吉寶西格斯 - 振華聯營公司  
KEPPEL SEGHERS - ZHEN HUA JOINT VENTURE

## PROPOSAL FOR RELOCATING IMPACT WATER MONITORING LOCATIONS C1, C2 and S2

KSZHJV	/	312	/	PRIWML	/	0001	/	C
Issuer		Project Code		Type of Document		Sequential No.		Revision Index

Integrated Waste Management Facilities, Phase 1

Figure 1.1 - Existing monitoring locations and fairway

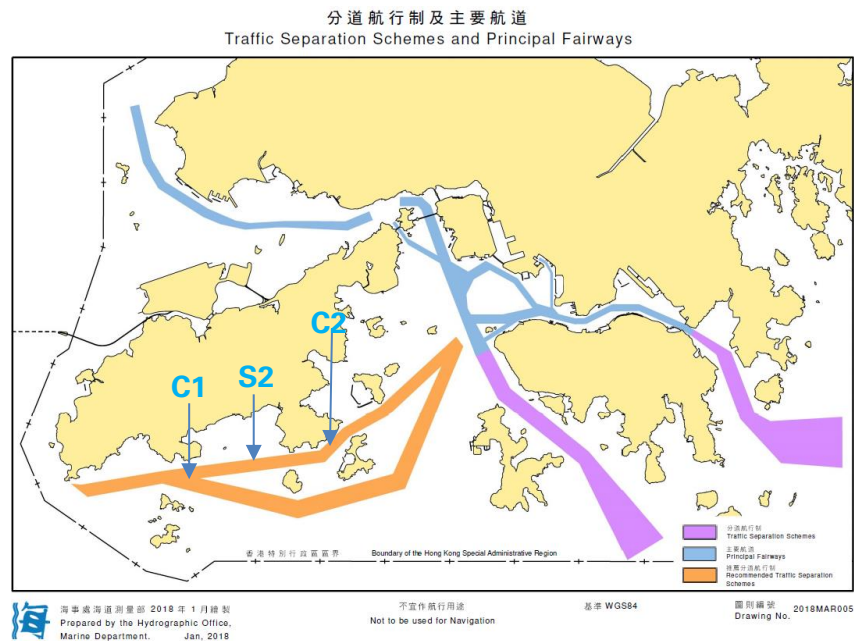
COMMENT ITEM REF.	REVIEWER'S COMMENT	ET'S RESPONSE
1. /	<p><u>Section 1.1</u> is suggested to be amended  <del>“1.1 As existing monitoring ... passing through. Since Marine Management Liaison Group (MMLG) Meeting No.7 dated 13 September 2018 raised out Marine Department and other stakeholders had raised out safety concern on marine traffic issues regarding shuttle boats travelling near Adamasta Channel where having frequent High Speed Ferry transit along in the Marine Management Liaison Group (MMLG) Meeting held in September 2018. (Attachment no.3 – MMLG minute no.7 item 3.3). In addition, there are marine constrains for this project. The vessel of ... Speed Ferry transits (See Attachment no.3 Presentation Slides no.9 &amp; 34 for the MMLG meeting).”</del></p>	Noted and revised.
2	To delete the extract of MMLG meeting minutes in Attachment 3.	Noted and removed.

- 1.1 As existing monitoring locations C1, C2 and S2 are situated at fairway, see below Figure 1.1, performing water monitoring at such locations possesses marine safety problem, especially turbojet vessel passing through. Marine Department and other stakeholders had raised out safety concern on marine traffic near Adamasta Channel in the Marine Management Liaison Group (MMLG) Meeting held in September 2018. The vessel of the project shall strictly follow traffic separation schemes and not obstruct any major traffic streams where fairway along Adamasta Channel with daily 300-400 no. of High Speed Ferry transits.
- 1.2 In order to enhance the marine safety but without adversely affecting the quality and accuracy of water monitoring, we are proposing to relocate the water monitoring locations C1 to C1A, C2 to C2A and S2 to S2A.
